Shad Fashion Ltd. (New Building)

Gorat, Ashulia, Savar, Dhaka
(23.944135, 90.302859)
22nd December 2020.

Observations

4000-liter water tank

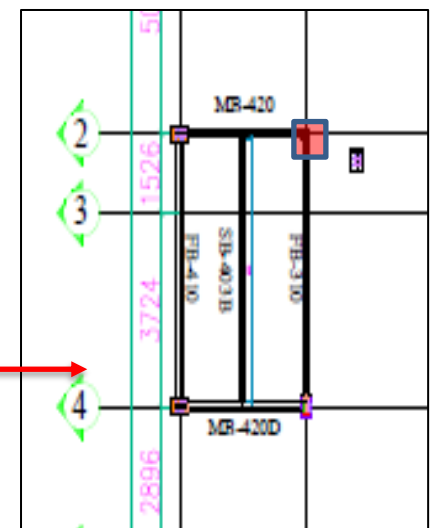
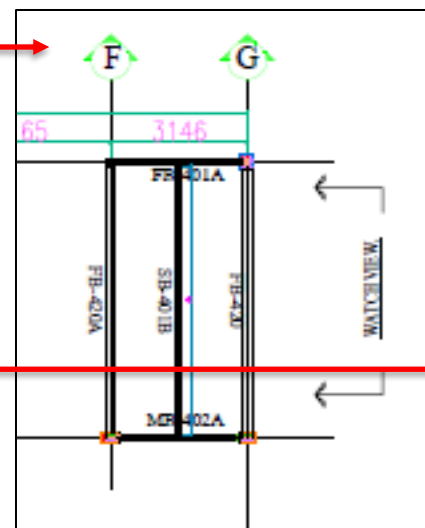
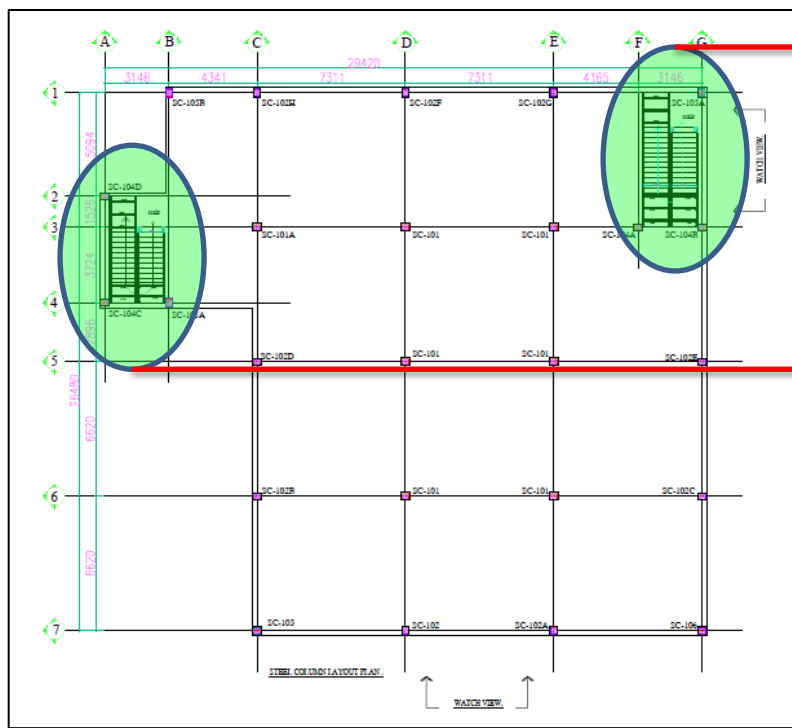
There are 2 water tanks on roof top whose allowable capacity is 4000-liter. But 4 nos. 4000-liter water tanks have been shown in as-built drawing & also water tank position has not matched with as-built drawing. Moreover, 6 nos. of toilets has shown in as-built drawing, but that area is open to sky on site.

Factory engineer is required to survey the hole structures and prepare accurate as built drawings.

Flange thickness found 5mm

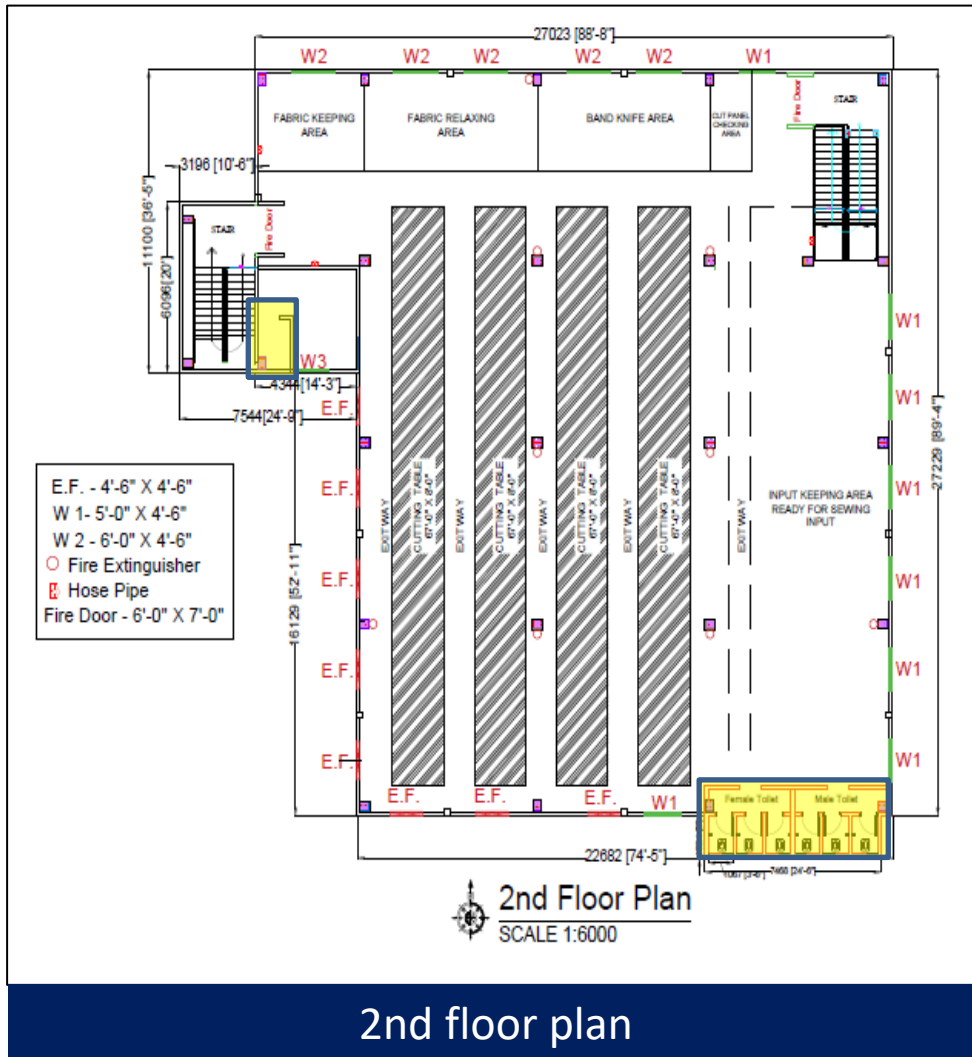
The details of stair sub-beam (SB-401 B & SB-403 B) has not been shown in drawing. The layout of stair main-beam (MB-420 D & MB-402) were found different with grid section. Moreover, the flange thickness of (FB-420 & FB-310) was measured 5 mm but in as-built drawing thickness was shown 6 mm.

Build-up at toilet zone

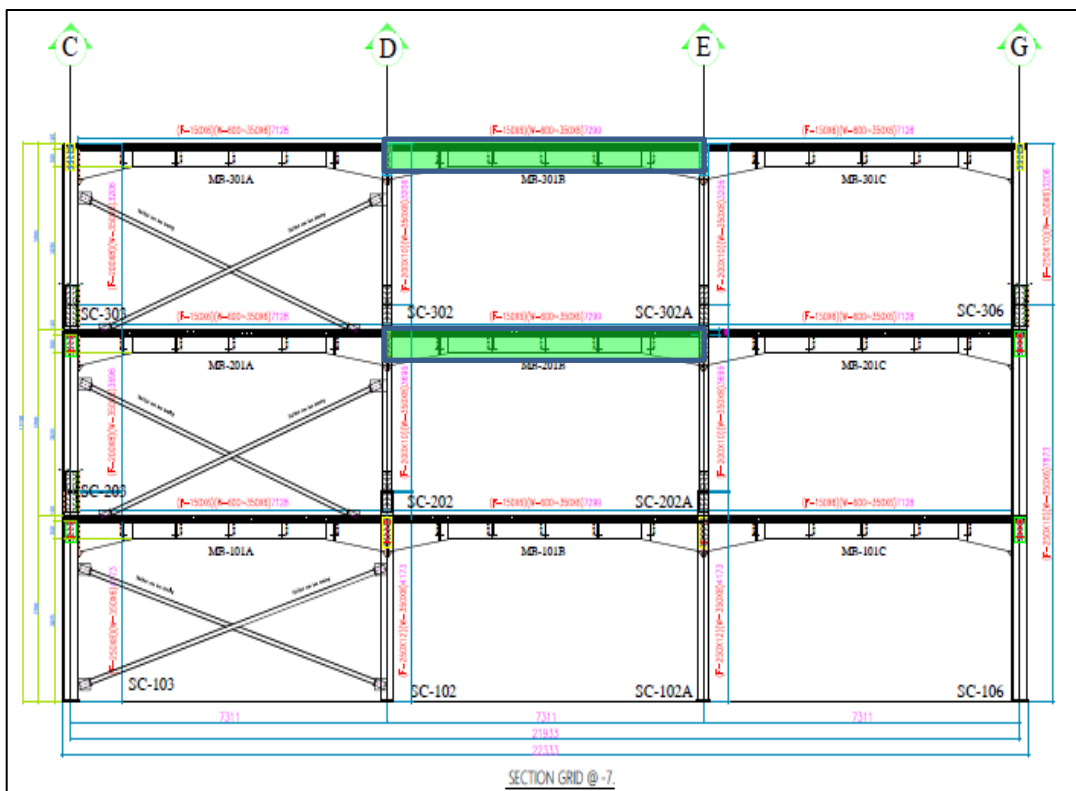
Floor Build-up was found at toilet zone area at site condition. Build-up height was measured approximately 200 mm. The information regarding build-up has not been shown in as-built drawing.

Flange thickness

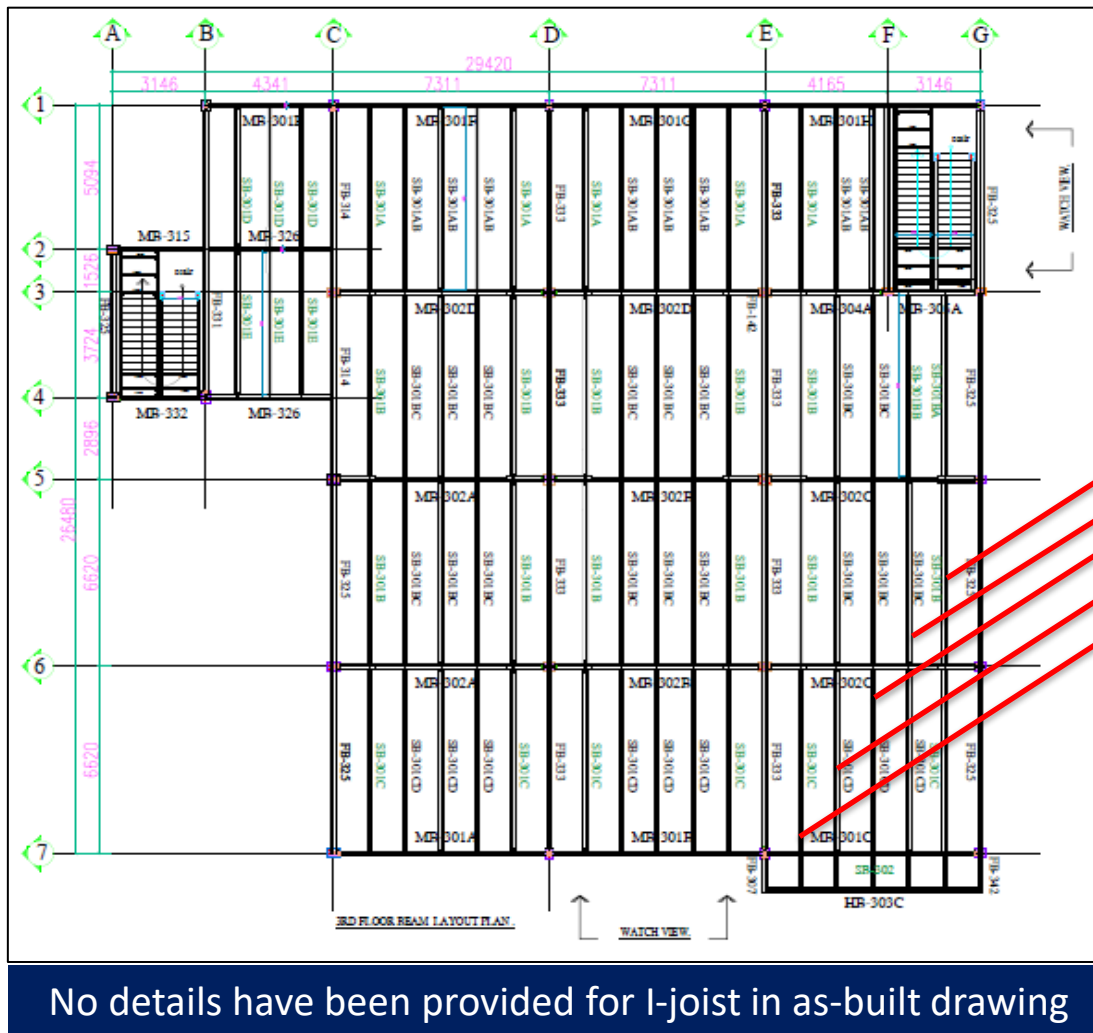
Flange thickness of primary floor beam MB-301G at grid-1 was found 5 mm on site instead of 6 mm. Also the flange thickness of beam MB-201B & MB-301B were found 5 mm in stead of 6 mm.

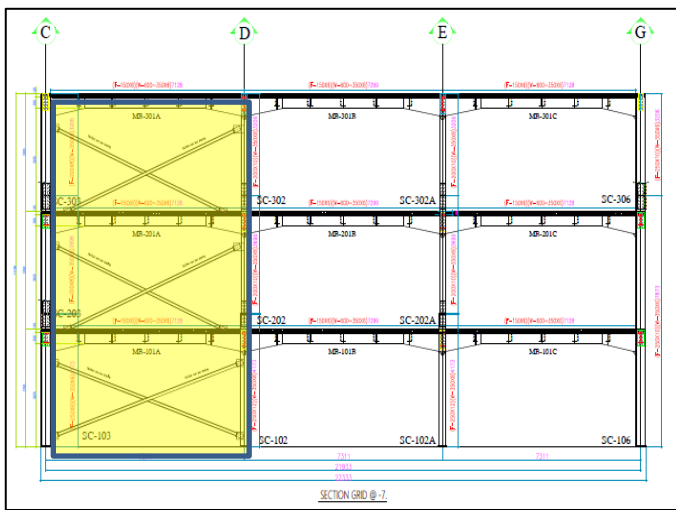
I-Joist (SB-301B) was found as W:275 mm; F: (150X5) mm on site

Tensile strength test report for steel sections (without mentioning the project name)

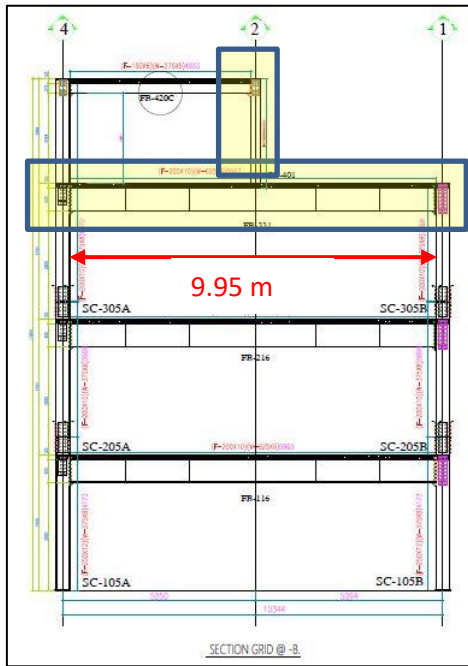
In design report tensile strength of steel plate has been considered 50 Ksi. But the factory provided test reports do not contain the project name as well as any reference of Shad Fashion Ltd. (New Building). So, the test reports can not be justified for considering the steel strength 50 Ksi. Moreover, no test report was found for the 10 mm & 8 mm steel plate which was widely used in beam & column.

Factory engineer is required to revise the design report considering the steel strength 36 ksi otherwise conduct plate test from the existing structure to proof the strength of the steel members for 50 ksi.
